RE: STPA RESPONSE TO INFORMATION REQUESTS 17 TO 34 INCLUSIVE

Remediation of Sydney Tar Ponds and Coke Ovens Site Information Requests (IRs)

Responses to IR-17 to IR-34

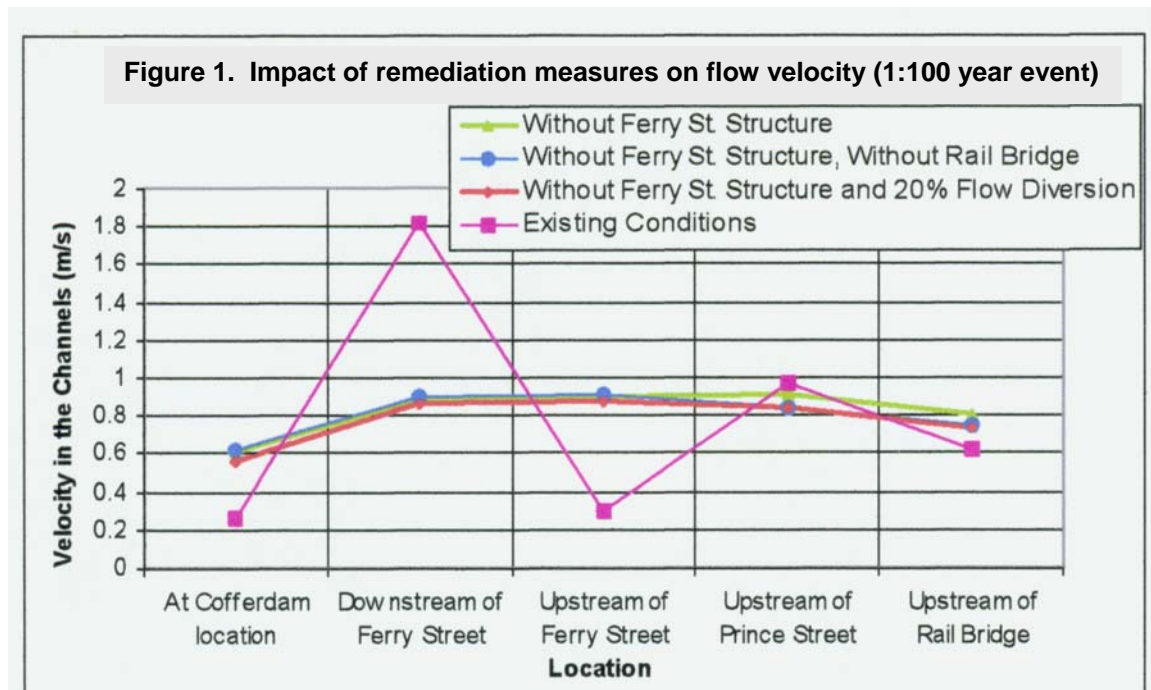
Section 2.13.2.1 of Volume 1 of the EIS indicates a single channel has been proposed for the channelization of surface water at the Tar Ponds site, but has provided no detail.

Provide greater detail regarding the channelization of surface water at the Tar Ponds site (depth, width, length, projected flow rates under normal conditions (including annual minimum and maximum velocities) and for storm events (1:100 year, 24 hour). Would the channel provide for fish passage? Would the channel be accessible to the general public once final landscaping is complete at the site?

The cofferdam construction will result in an increase in water levels of 1 – 3 cm for the 1 in 100 year peak flow event. This is a very minor impact and, considering the short duration of time that Muggah Creek will discharge through the cofferdam opening while the channel construction is underway, is a low risk occurrence.

The channelization approach was also modelled during the cofferdam conceptual design. This modelling determined a minimum channel width of 20 m to carry the surface flows through the ponds to the harbour while maintaining or improving existing hydraulic conditions. Hydraulically, as long as the cofferdam does not create any restriction to the flow that is greater than what is required, it will produce no impacts. A cofferdam with an opening sized this way is acceptable as long as the full opening width is used for any of the temporary and/or final channels. The modelling included the cofferdam (50 m opening) and channel (25 m wide) scenario for the 1 in 100 year peak flow event, with the results shown in the following table.
